Project: Proposed Interior Alterations along with Upgrades to Exterior Façades including New Dark-Sky Compliant Site Lighting & Upgraded Landscaping for ThermoDynamics Corp. – HVAC Contractor and Service Company
2989 Navajo Street, Yorktown Heights, NY 10598
Tax Assessor Section 6.18, Block No. 1, Lot No. 30
Owner: McBrothers Realty, LLC – Ryan McCormick, Member

Subject: Application for Site Plan Approval (Site Plan – Formal)

To: Planning Department
From: ABACA
Date: August 10, 2022
Subject: Thermo Dynamics Corp.
6.18-1-30; 2989 Navajo Street

Subject: Application for ABACA Approval
(Revised Drawings dated 08/11/22 incorporating ABACA Recommendations)

PROPOSED LANDSCAPE PLAN / UPGRADES

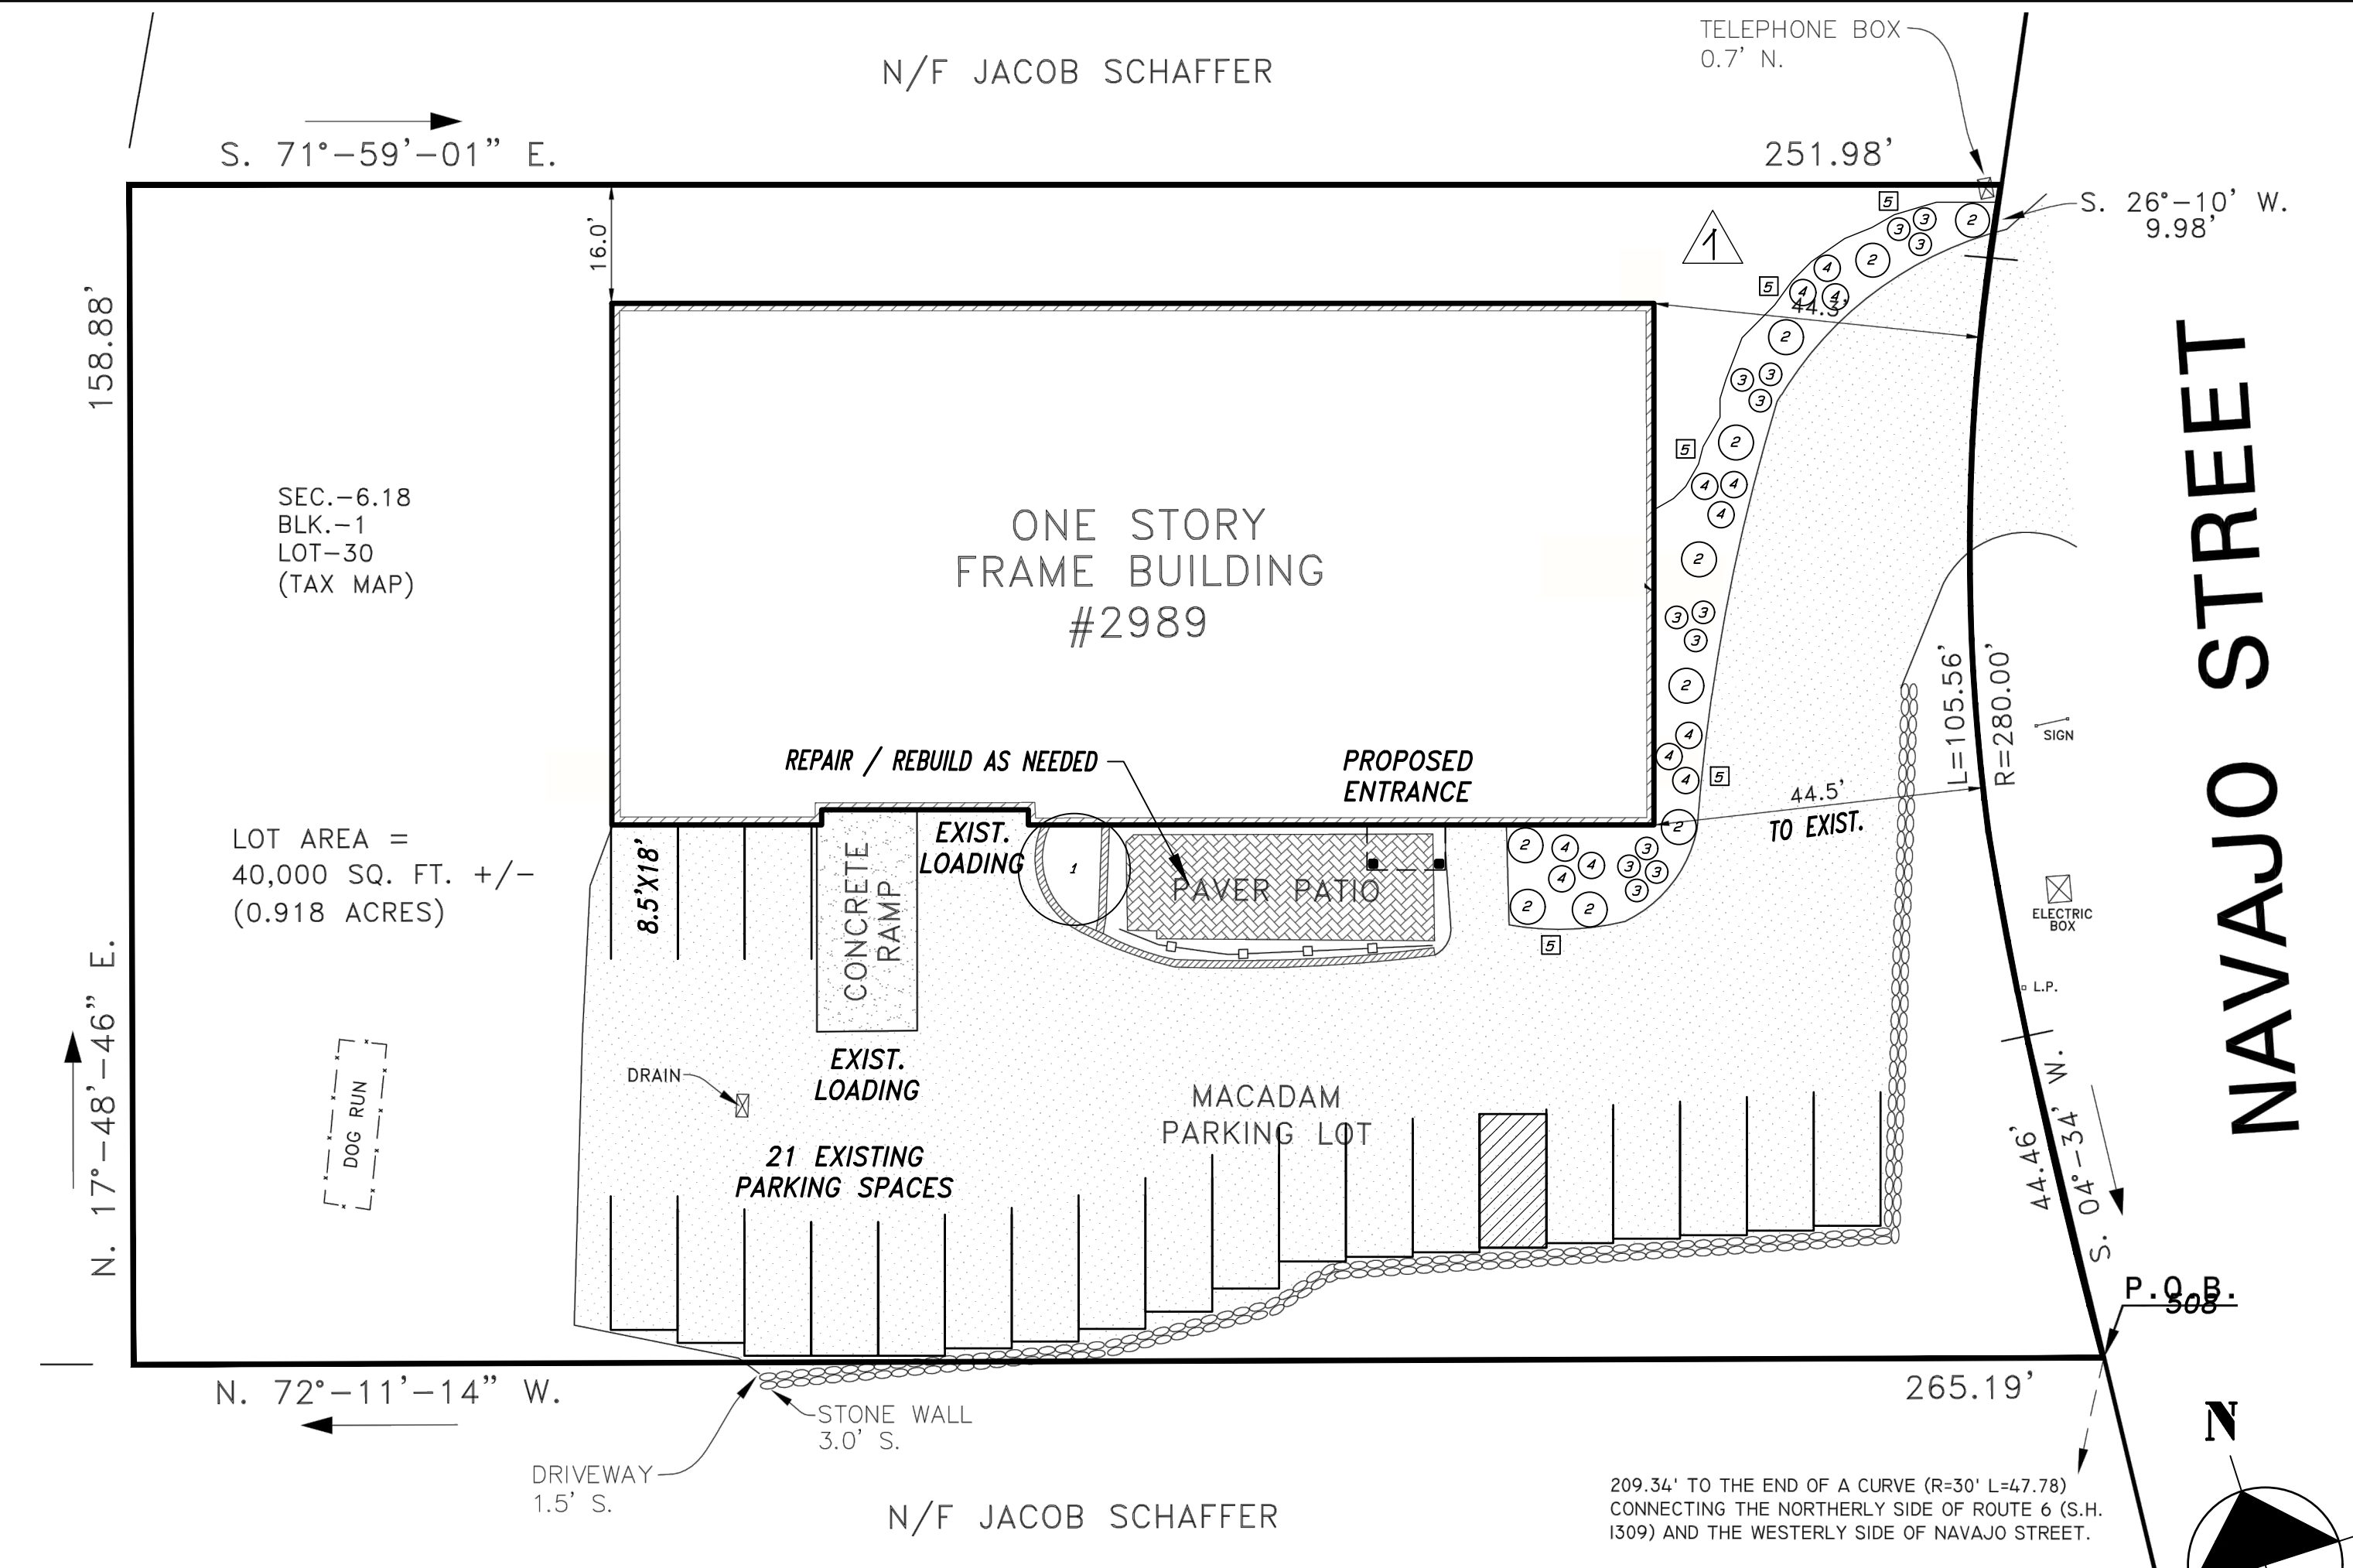
The applicant submitted a preliminary planting plan to demonstrate the intent to improve the landscaping at the entrance of the site and to soften the façade. The Board appreciates the intent and requests for the applicant to provide an enhanced professional landscape design that addresses the following comments:

- Plants should be grouped logically and sizes and materials should be confirmed.
- Plant selections and placement should be appropriate and should work to accent the architecture.
- The plan is to include a four-season maintenance plan.

5. **Landscape Maintenance** – The Town Requirements for Landscape Maintenance have been included on the Drawings underneath the Proposed Landscape Plan (See Drawing C-2). The Owner is also aware of these requirements and will make sure that all lawns and landscaping are properly maintained.

LANDSCAPE PLAN	
FOUR SEASON MAINTENANCE SCHEDULE	
SPRING	General cleanup and maintenance to be performed around the entire property. Prune and maintain trees and shrubs as required to maintain the natural plant appearance. All fallen and dead branches are to be removed. Any dead plants are to be replaced. Fertilizer is to be used on the trees (<i>Ericaceous fertilizer on all Azaleas</i>). Shrub fertilization shall be performed using slow release, complete organic based products. Weed killer to be used on lawn as a pre-emptive effort to prevent growth.
SUMMER	Lawn is to be mowed as required to maintain a grass height of 3 inches. All fallen or dead branches to be removed as required. Any dead plants are to be replaced. All open lawn areas are to be watered as conditions dictate throughout the season.
FALL	General cleanup around property to be conducted as required. Leaves and branches are to be cleared from all open lawn areas. All bare spots on the lawn are to be fertilized and reseeded as necessary. Shrub fertilization shall be performed using slow release, complete organic based products.

ISSUE DATES:		ALTERATIONS TO EXISTING BUILDING for: THERMODYNAMICS CORP.	
		2989 NAVAJO STREET	YORKTOWN HEIGHTS, NEW YORK 10598
		PROPOSED EXTERIOR ELEVATIONS SCALE: AS INDICATED	
		DRAWN BY: NED	
		CHECKED BY: PJH	
		DRAWING NO.:	
8-11-22 ABACA REQMTS 8-5-22		A-2

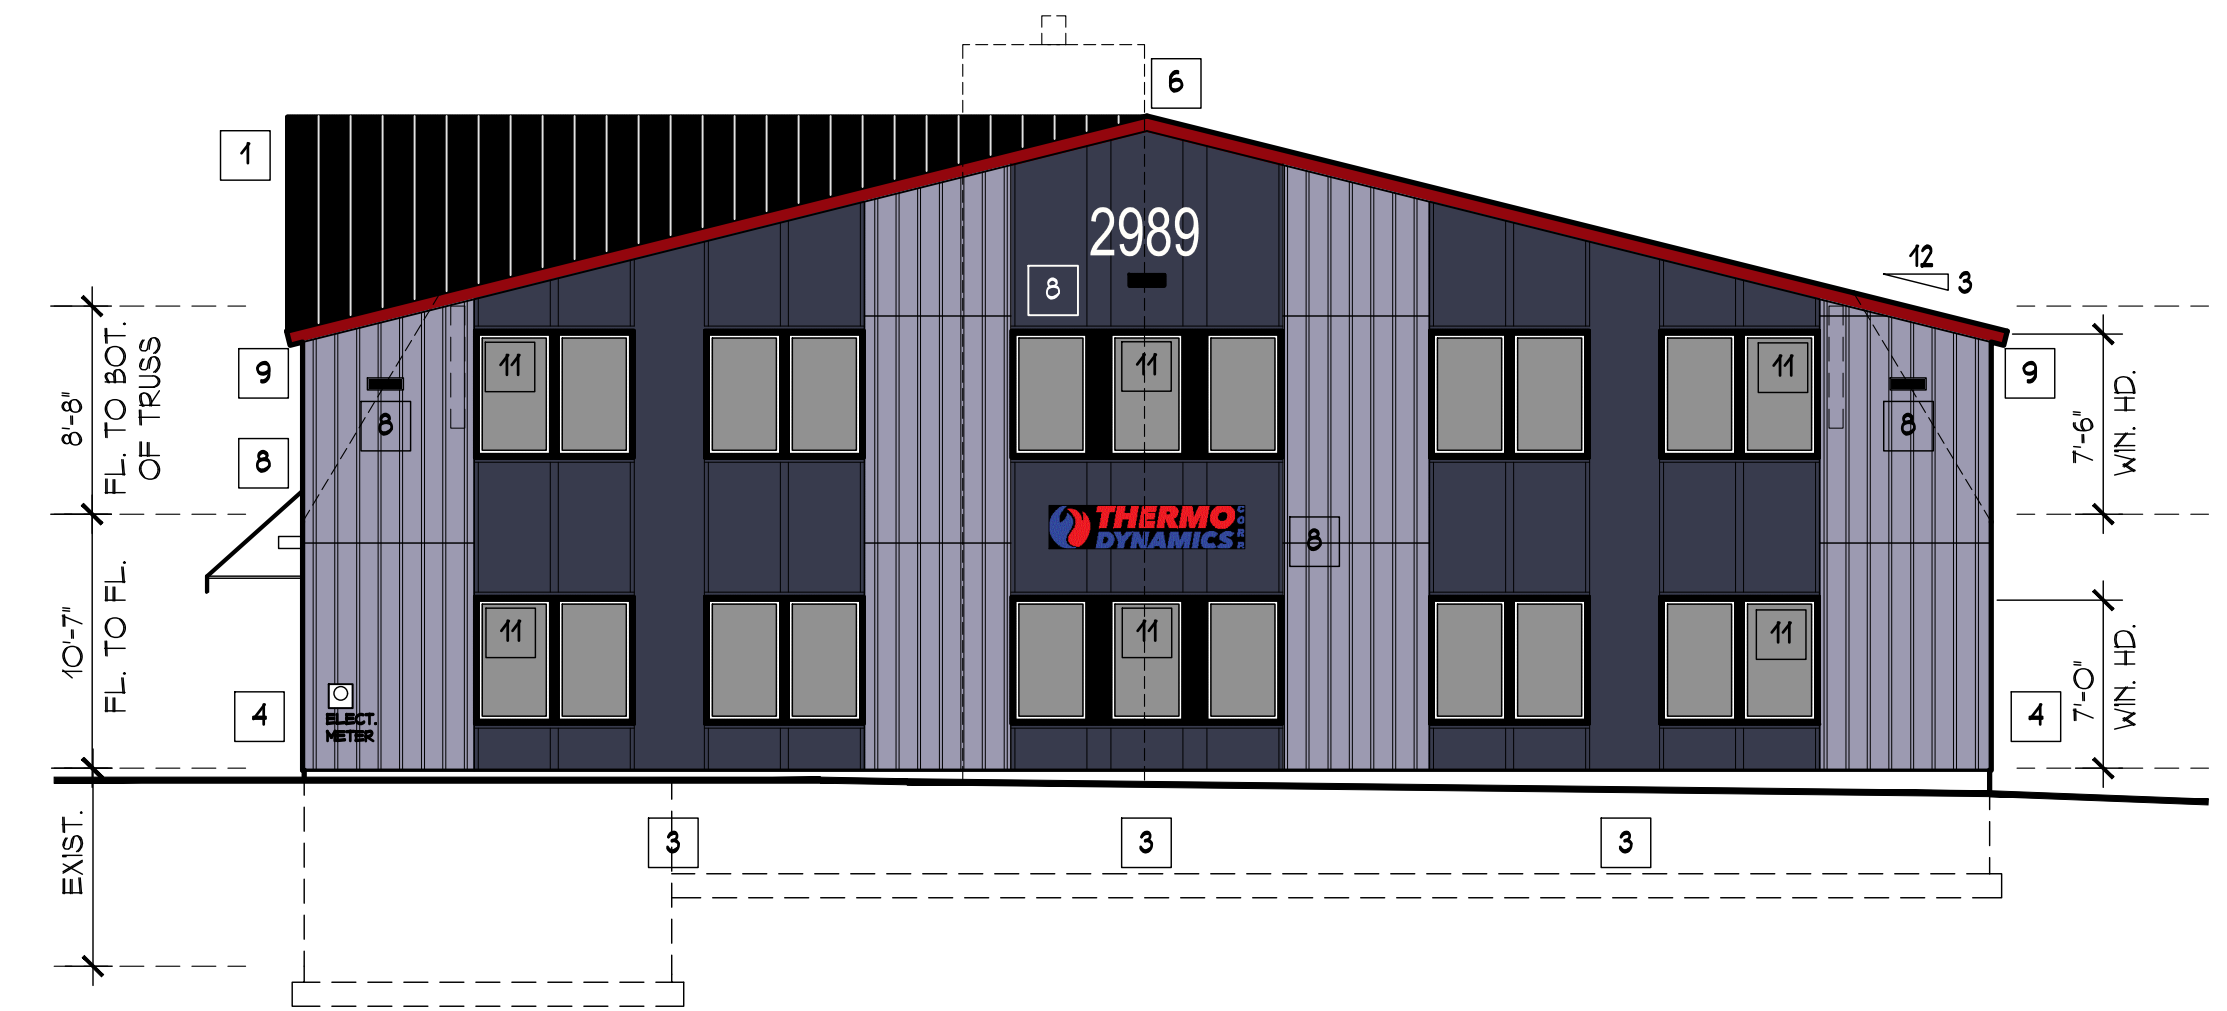
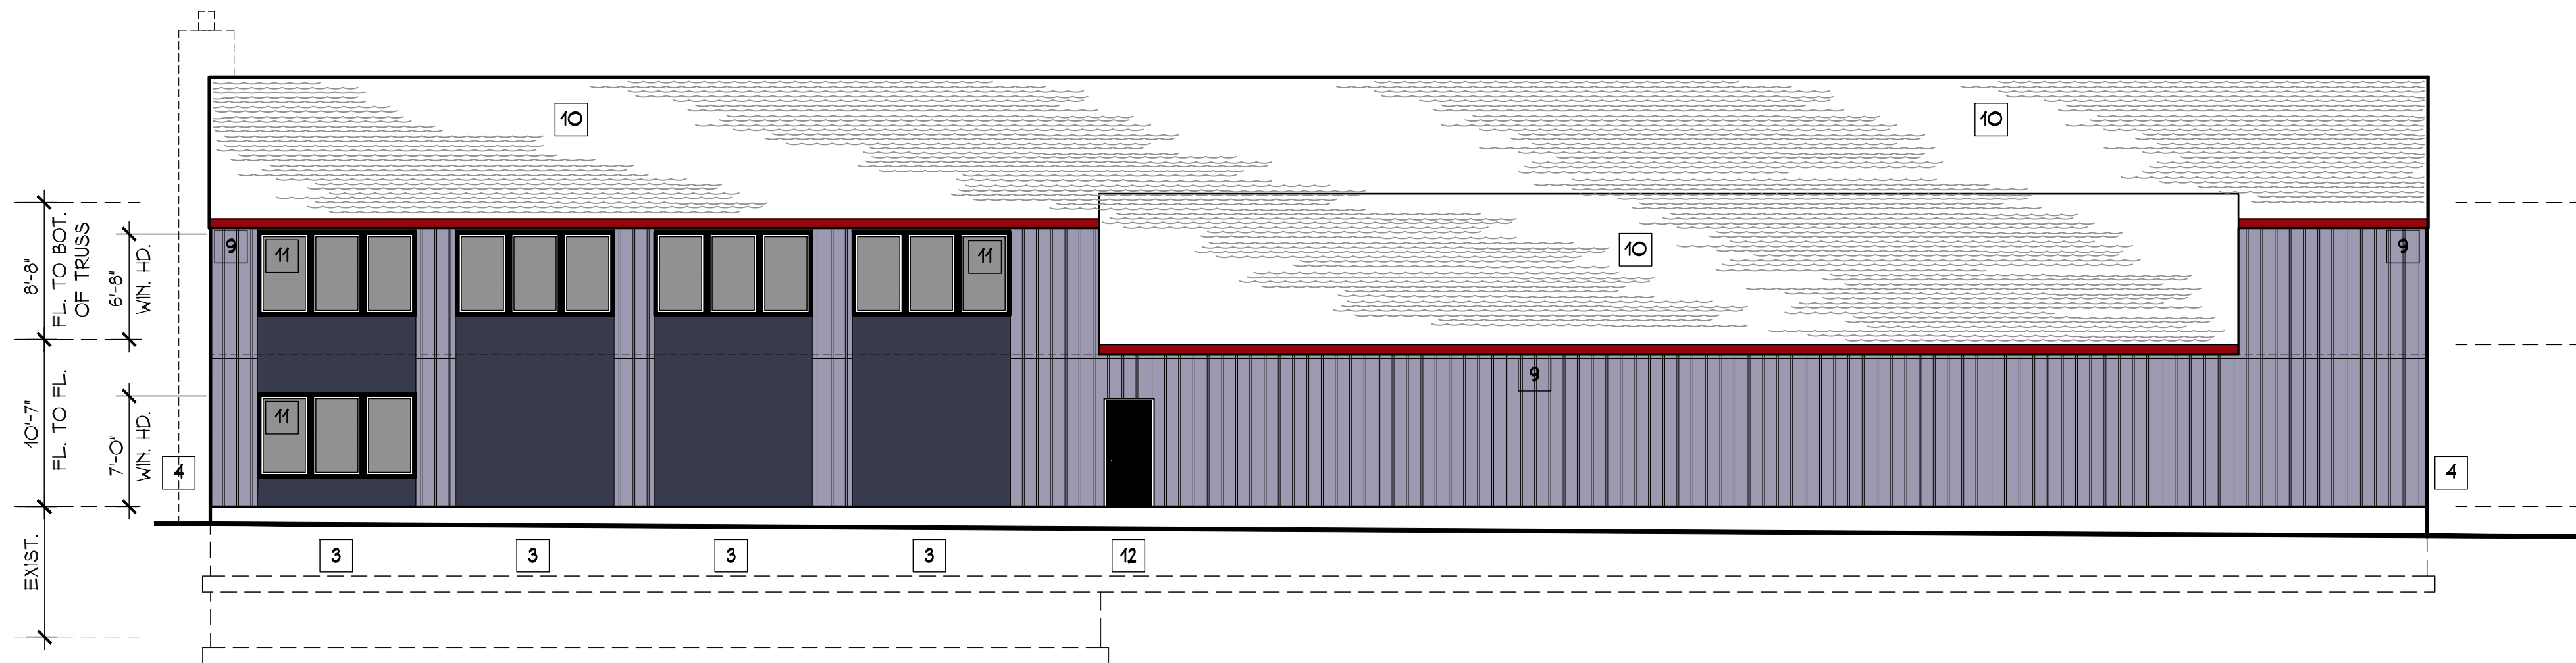
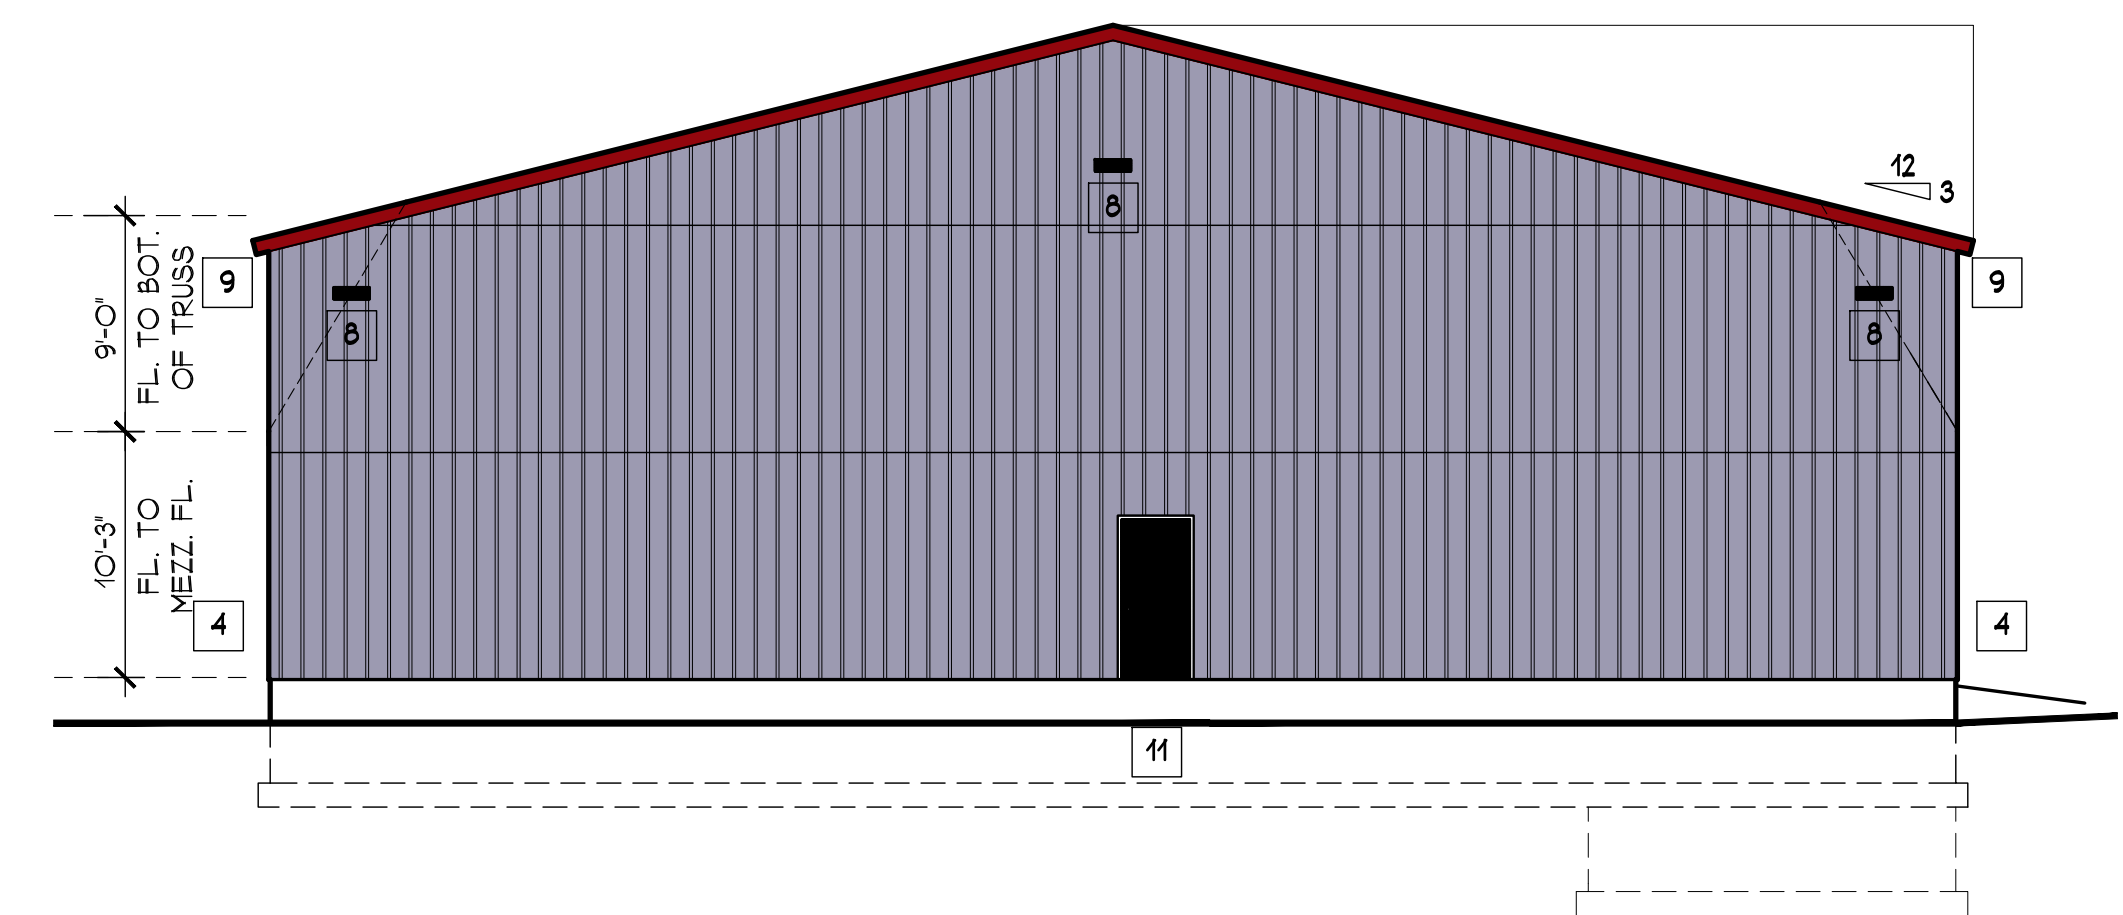
2. **Garage Doors** – The attached Revised Drawings indicate the Proposed Windows in the top section of the two (2) new overhead garage doors. This was not indicated on the original Drawing submission. We wanted to add these windows to permit natural light / daylighting into the warehouse space.

7. **Exterior Material List** – In addition to the General Legend of Exterior Materials found on Drawing A-2, the attached revised drawing also includes a Detailed Listing of all Materials as well as the selected colors and the Manufacturer's name for each different component.
